Warrenton Planning Commission

5. **PUBLIC HEARING: SDR-20-6 The Scoular Company (Tom Wortman), to develop a 14,000 square foot fishmeal processing facility on property owned by the City of Astoria located on Airport Way in the Airport Industrial Park.**
6. **PUBLIC HEARING: AP-19-3 an appeal filed by Scott Widdecombe of an administrative decision (20-PE-03) to extend previous Planning Commission approvals SDR-19-06 and CUP-19-02 for Pacific Seafood for an additional year. The property is located at 1815 NW Warrenton Drive; taxlot 81009B000500**
7. **Staff announcements & Project Updates**
8. **Next Meeting: November 12, 2020**

TO: Warrenton Planning Commission
FROM: Mark Barnes, Interim City Planner
RE: Site Design Review Application, SDR 20-06, The Scoular Company

Re: Port of Astoria – Scouler Fishmeal Facility – Planning Application Review

SITE DESIGN REVIEW PLAN
SCALE: 1" = 20'

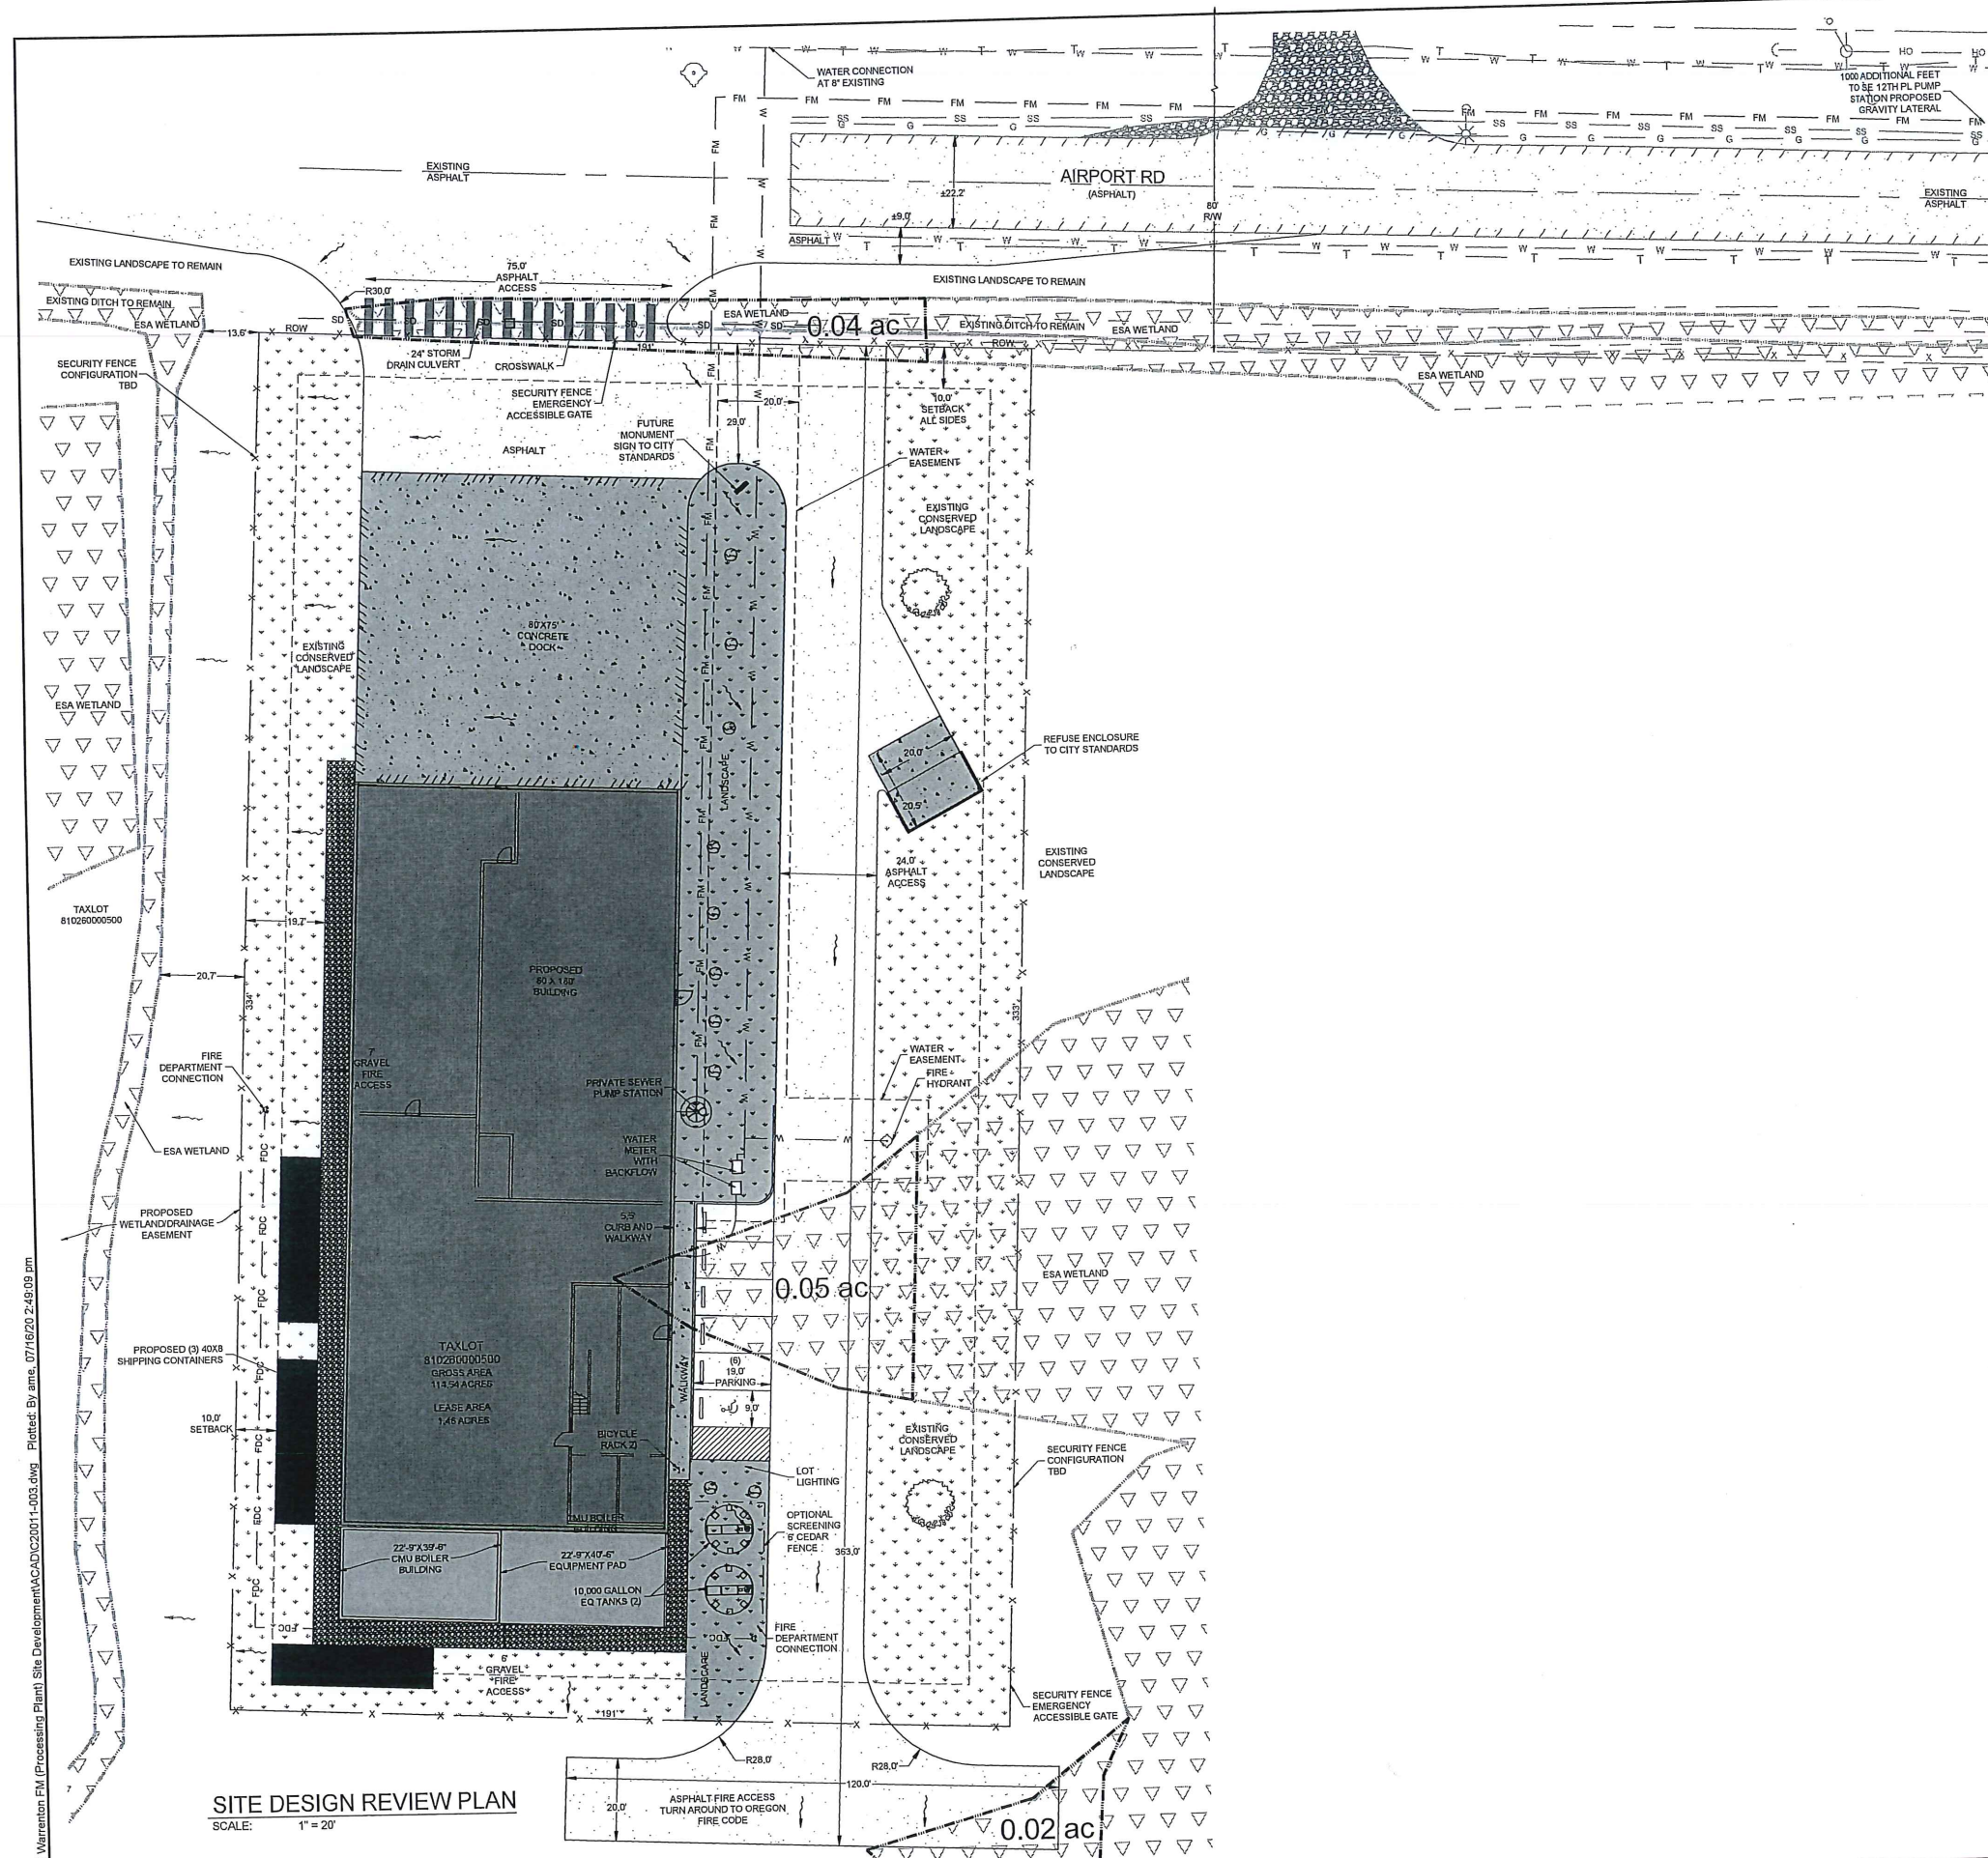
The proposed site plan shows fencing around the entire site perimeter. The City restricts fences in the I1 zone to six feet in height (16.124.050.B.1). See proposed approval condition 1.

Setbacks are typically measured from the property line. In this case, staff recommends that setbacks instead be measured from the fence line, which is the lease-hold boundary. The proposed shipping containers, shown on sheet C2, would be located ten feet from the west fence line. A single shipping container located on the south side of the building is closer than ten feet from the fence line. The proposed building is 19 feet from the west property line, and more than ten feet from the south fence line.

shows a landscaped strip about twenty feet wide along the loading dock's east side. The site plan shows three shipping containers along the proposed building's south and west side. If these are outdoor storage, they should be screened. If, on the other hand, these are buildings, they need to be connected to the site's pedestrian circulation system. The proposed site plan shows an unscreened "equipment pad" on the building's southeast corner. This should be screened unless operational considerations prevent it: see proposed condition 5.

1. The perimeter fence shall not exceed six feet in height.
2. Applicant or property owner shall provide the City with a copy of a written statement from the Oregon Aeronautics Division indicating that the proposed use will not interfere with operation of the landing facility.

FIRE TRUCK TRACKING
 SCALE: 1" = 50'

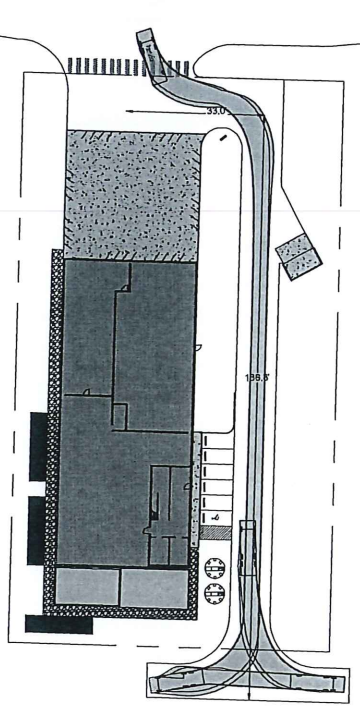
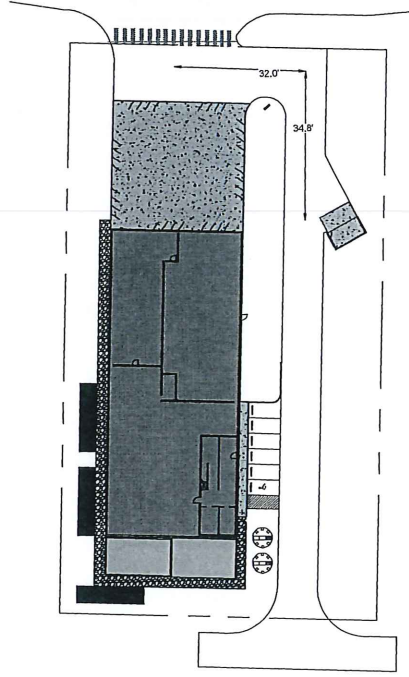
20. Show turning paths of fire truck, garbage truck, busses, and tractor-semitrailer at the intersection Hwy 101 business/Airport Lane.
21. Final stormwater report will include a downstream analysis for all impacted stormwater systems and end at the Youngs Bay or Lewis and Clark River. Analysis shall include pre and post development flows and note any current or future deficiencies. Provide a drawing that clearly shows storm drainage paths and includes existing and proposed infrastructure. Provide one sheet that shows entire stormwater system.

C4

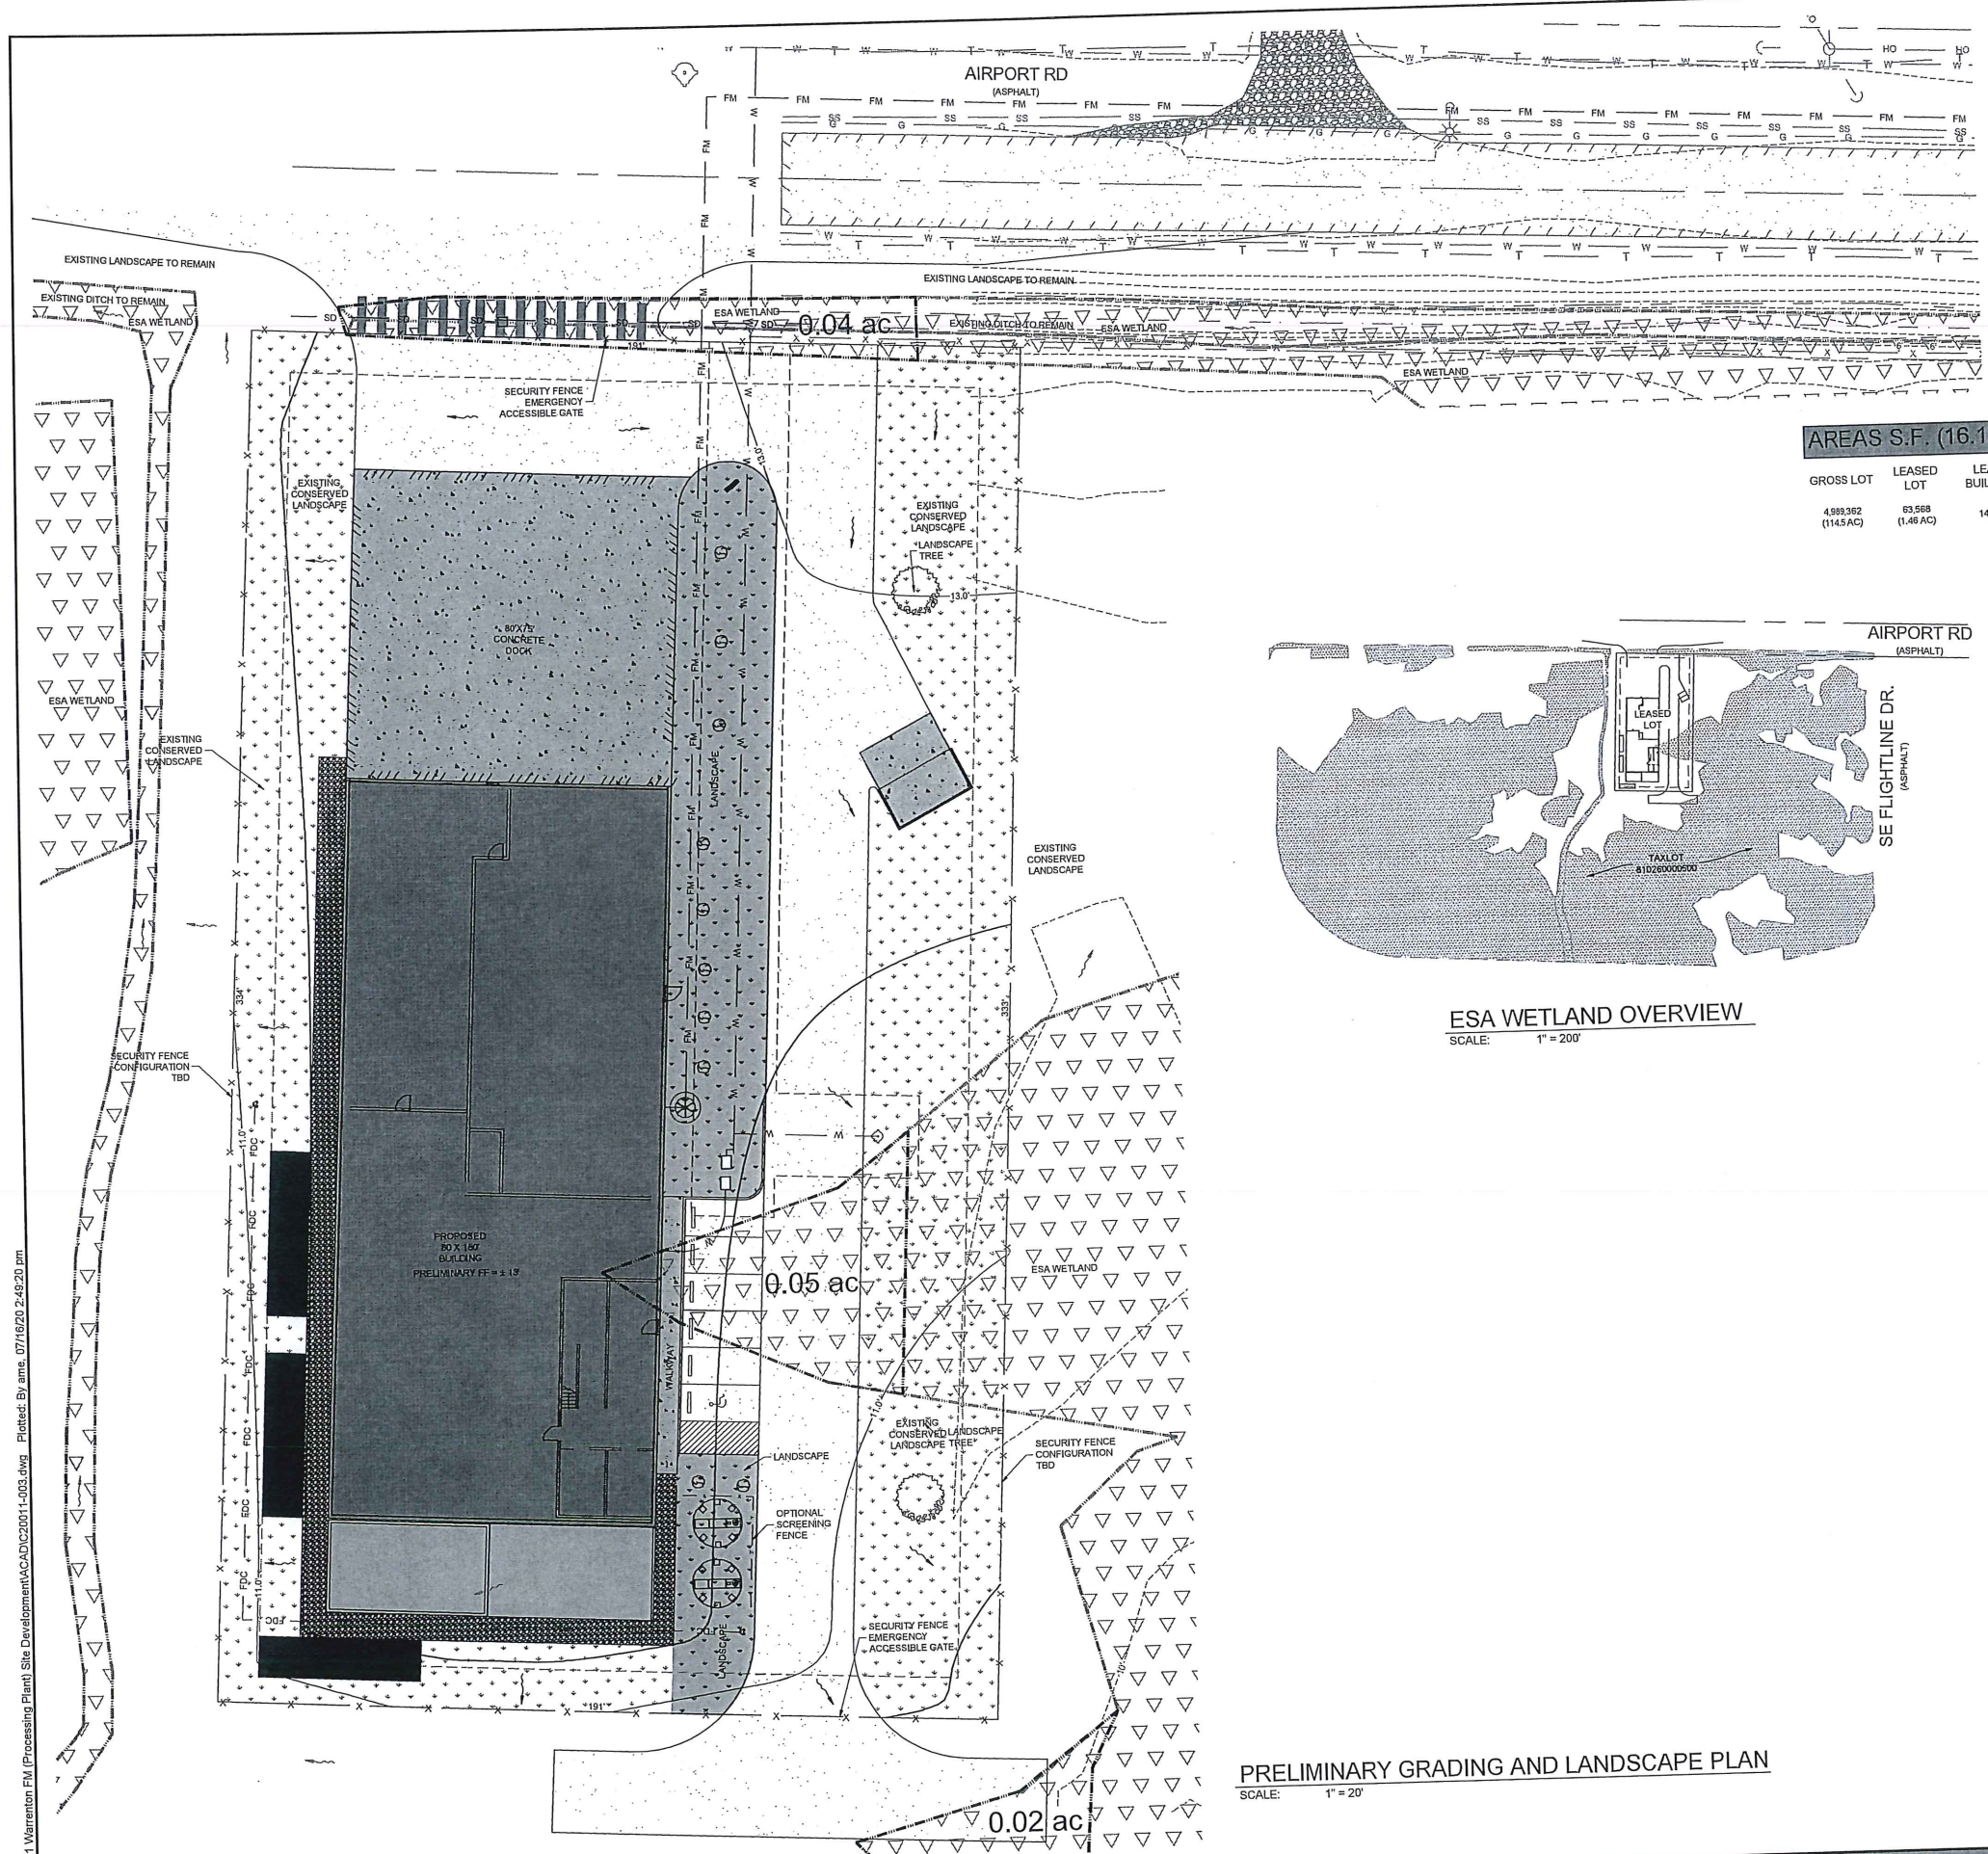
The proposal includes a landscape plan on sheet C4.

The proposed landscape plan shows that interior landscaping will cover 41.5 percent of the development site. This includes about 18,000 square feet of undeveloped open space on the lease site.

The proposed landscaping plan provides for a refuse enclosure to City standards. It is not clear whether this includes screening: see proposed approval condition 5. Two 10,000-gallon tanks near the southeast corner for the proposed building have an "optional screening 6' cedar fence". This should not be optional: see proposed approval condition 5. The proposed loading dock cannot be screened from the street given its current orientation. The landscape plan

4. Sheet C4 provides the elements of a landscape plan. First, I could not find language in your application materials concerning landscape maintenance. This was identified in the City's May 27, 2020, memo to the applicant: "Maintenance provisions for landscaping and other common areas shall be included in a lease agreement and a copy provided at time of application." Second, the landscape plan (sheet C4) includes a plant list. As I read it, this would apply only to the area immediately east of the building. Most of the landscaping would be "existing conserved landscape", and would not be planted with the species listed in the proposed plant list. Is this correct? If so, the plan should list the dominant species in the conserved areas.
